ADDENDUM NO. 1

**Cherry Tree Softball Complex Renovation Phase 2
13989 Hazel Dell Parkway
Carmel, IN 46033**

Carmel High School Softball Complex Renovation – Phase 2

Project No. 224041.00

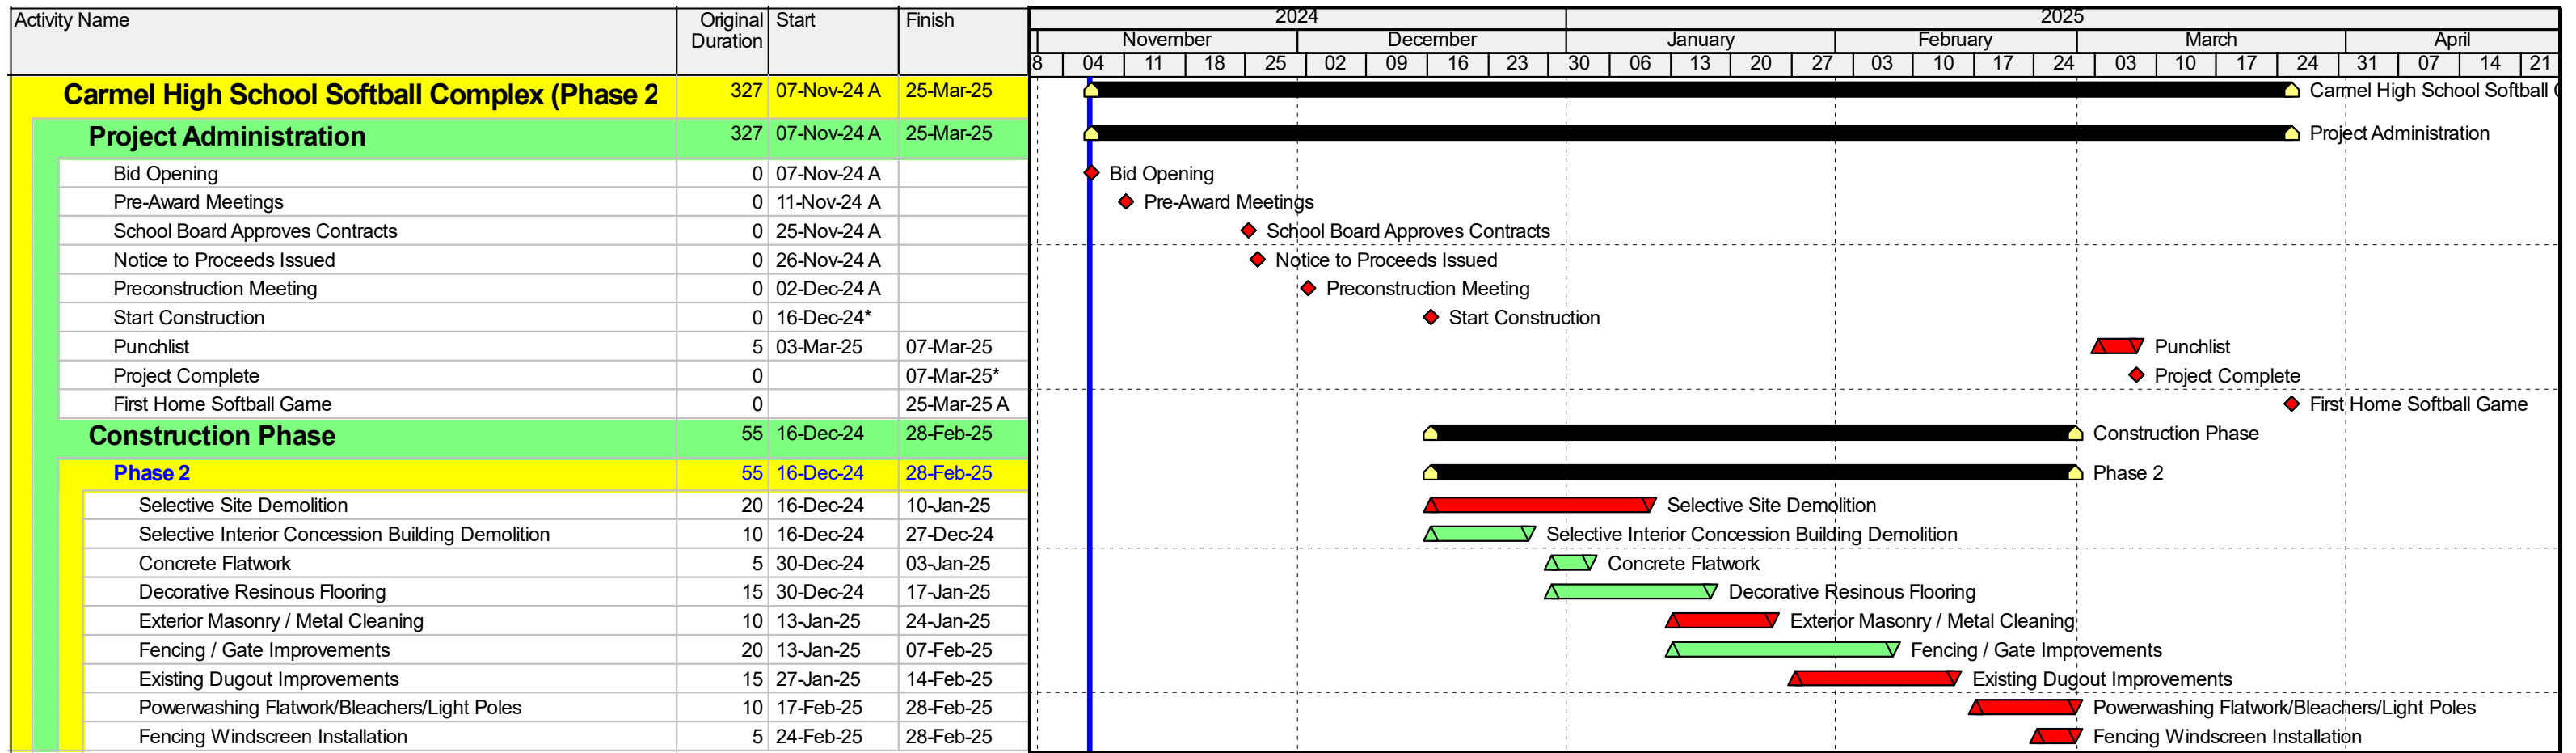
Revise Clarification No. 3 to read as the following:

3. Contractor shall include total of (500) brick pavers as a product allowance to be removed and replaced at the Construction Manager's discretion per Demolition Keynote No. 21 on Drawing Sheet GD1.01. All remaining brick pavers at Project Completion to be turned over to Owner as attic stock.
